Evaluation of Geologic Information in the CTV III CO₂ Sequestration Project Class VI Permit Application

Comments on CTV III Computational Modeling
Class VI Pre-Construction Permit Application No. R9UIC-CA6-FY22-5.1-5.6

ENCLOSURE
Request for Additional Information
Project Interference with the Pelican Renewables and CTV V Projects
Carbon TerraVault Holdings LLC (CTV) III Project
Underground Injection Control (UIC) Permit Application
Class VI Pre-Construction Permit Application Nos. R9UIC-CA6-FY22-5.1-5.6

Figure 1: Proposed Area of Reviews of the CTV III, CTV V, and Pelican projects.

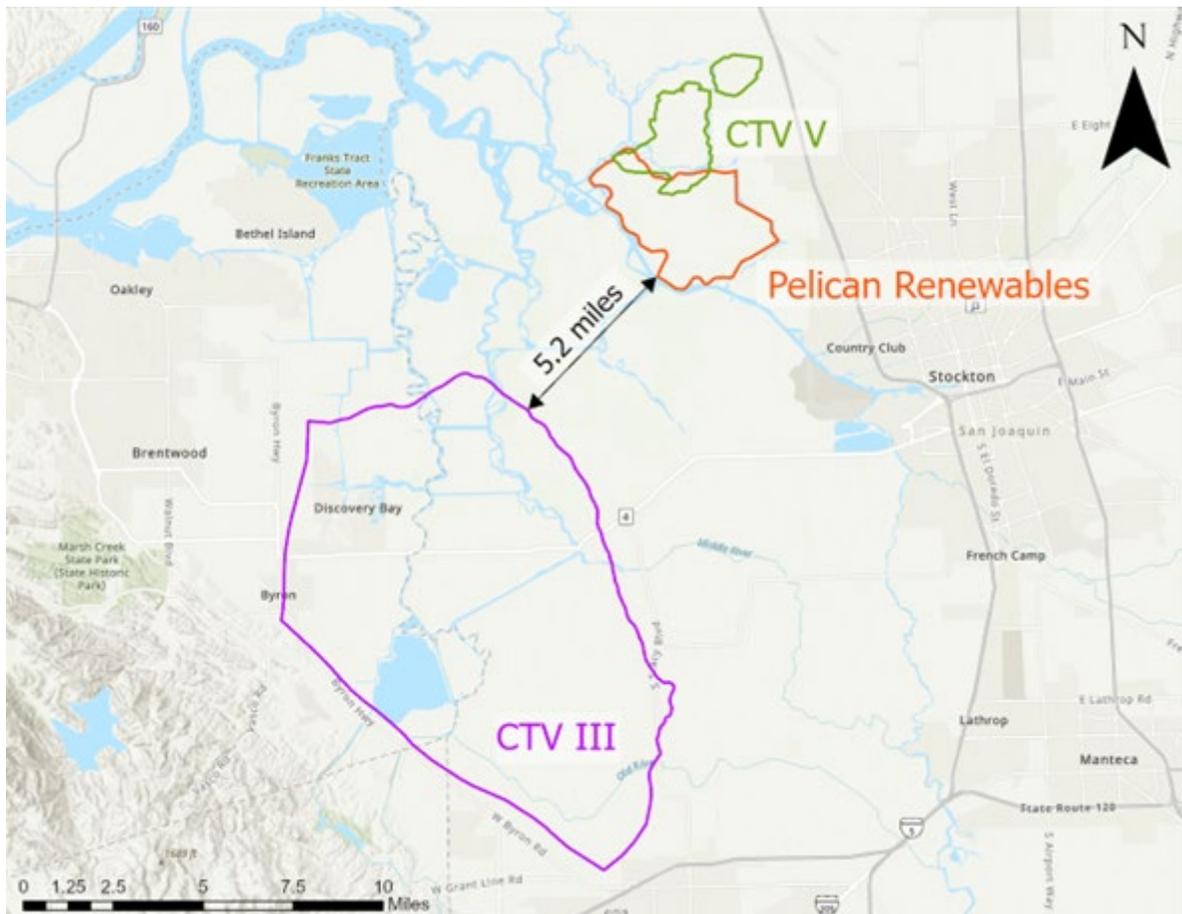
This Enclosure for the proposed CTV III Class VI geologic sequestration project summarizes an issue that came to light during the technical review of this project and during the technical review of other Class VI permit applications located near CTV III's Area of Review (AoR). The Pelican Renewables (Pelican) project is proposed to be located on Rindge Tract Island and has a calculated AoR approximately five (5) miles away from the CTV III AoR, and the CTV V project located in Sacramento Valley, nine (9) miles east of the Rio Vista Gas Field and four miles northwest of Stockton, California is also close to the proposed CTV III project. A preliminary investigation determined that the pressure changes from the three projects are overlapping.

The three projects present similar geological models and subsurface stratigraphy that need to be investigated due to their potential to overlap. For example, pressure propagation results for CTV III and

EPA guidance¹ states that “In all cases, EPA recommends that AoR delineation models account for all wells injecting into (including any injection wells associated with other UIC well classes or other Class VI operations) or pumping from the injection zone or any other zones that are hydraulically connected to the injection zone.” Pressure plumes follow the principle of superposition, where pressure is additive. Thus, to correctly calculate the AoR for these three close sites, CTV and Pelican should include the pressure buildup of the other sites in their calculations; for example, add an extra injection well to reflect the total injection volume from the other projects in the simulations.

Figure 2: Comparison of pressure impacts from the CTV III project (left) and the Pelican project (right).

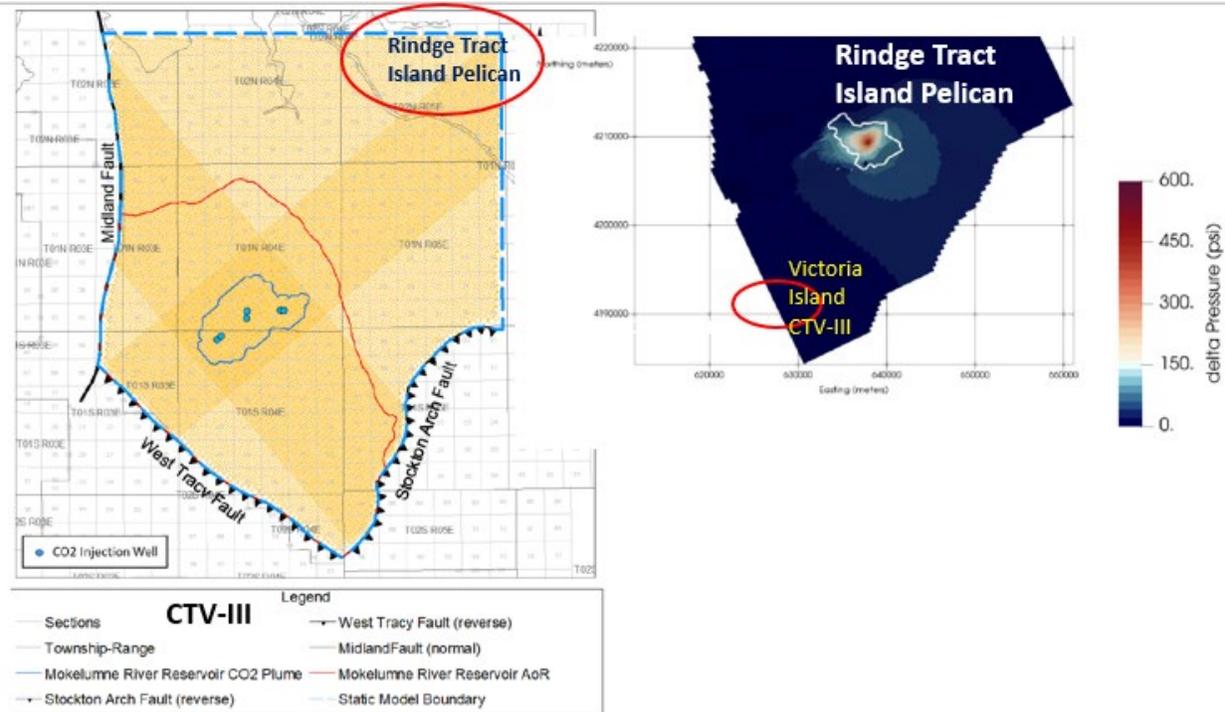
Pelican are shown in **Figure 5** where the red line on the left side of the figure is the extent of the AoR for CTV III, and the right side of the figure shows the pressure change (delta Pressure) for Pelican.
